APPLICATION NO.	FILING DATE	FIRST NAMED INVENTOR	ATTORNEY DOCKET NO.	CONFIRMATION NO.
10/764,509	01/27/2004	Jung Tac Kang	AB-1634-1D US	9956
32605	7590	10/30/2008		
MACPHERSON KWOK CHEN & HEID LLP				
2033 GATEWAY PLACE				
SUITE 400				
SAN JOSE, CA 95110				
EXAMINER				
NGUYEN, JIMMY H				
ART UNIT		PAPER NUMBER		
2629				
MAIL DATE		DELIVERY MODE		
10/30/2008		PAPER

### Office Action Summary

### **DETAILED ACTION**

**Annotated Figure 1**

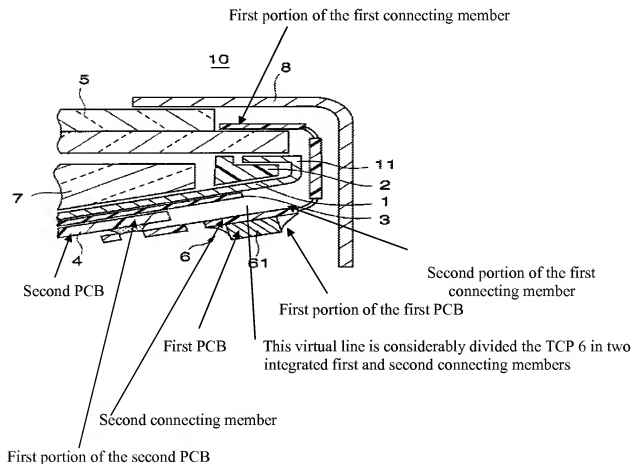
a first connecting member (a first portion of the TCP 6, which considerably includes two integrated first and second portions; see the below annotated Fig. 1) attached to a first portion of a front plane of the display panel (5) (Fig. 1);

a first printed circuit board (a circuit board having a driver IC 61 disposed thereon; Fig. 1) comprising a source PCB (61) closely attached to the rear plane of the mold frame (1, 2) and electrically coupled to the display panel (5) through the first connecting member, the first connecting member being attached to a first portion of the first PCB (see the below annotated Fig. 1), the first connecting member partially overlapping with the first PCB (see the below annotated Fig. 1); and,

a second PCB (a driver circuit board 4; Fig. 1) comprising a driving circuit PCB (4) closely attached to the rear plane of the mold frame (1, 2) and having a first portion electrically connected to the first PCB without using a separate connecting member (the below annotated

Fig. 1 shows a first portion of a second PCB connected to the first PCB via a second portion of the TCP 6, which is **NOT** separate from the first portion of the TCP 6, i.e., a second portion of the TCP 6 does not correspond to the claimed “separate connecting member”).

claim 37 (see the above annotated Fig. 1). Further, as shown in the annotated Fig. 1 above, Murai discloses a second connecting member (the second/left portion of the TCP 6) attached to a second portion of the first PCB (61); a second PCB (4) electrically connected to the first PCB (61) through the second connecting member (the second/left portion of the TCP 6); and the second connecting member (the second/left portion of the TCP 6) attached to a first portion of the second PCB (4). See the above annotated Fig. 1.

13. Applicant has amended claims 18 and 37 to include a limitation, “the first connecting member partially overlapping with the first PCB” and argued that Murai does not teach this feature (see the amendment, page 7, last paragraph. Examiner disagrees because as discussed in the detailed rejection above, the element 6 considerably includes two integrated connecting members, the first (right) connecting member of the element 6 attached to the first PCB 61 and partially overlapping with the first PCB 61 (see the above annotated Fig. 1). Applicant further argued that Murai discloses the element 4 connected to the element 61 using a separate connecting member (the element 6). Examiner disagrees because as discussed above, although Murai discloses the element 4 connected to the element 61 using a (second/left) connecting member of the element 6; however, a (second/left) connecting member of the element 6 is NOT separate from the first (right) portion of the element 6. Furthermore, there is no where in the Murai to disclose that the element 6 can be separated from the element 4 or element 61 (e.g., elements 4, 6, 61 may be all soldered together).

Examiner disagrees because as discussed in the rejection to claim 37 above, Murai's TCP 6 considerably includes two integrated first (right) and second (left) portions, the first (right) portion of the TCP 6 corresponding to the claimed first connecting member of claim 37 and the second (left) portion corresponding to the claimed second connecting member of claim 37 (see the above annotated Fig. 1).
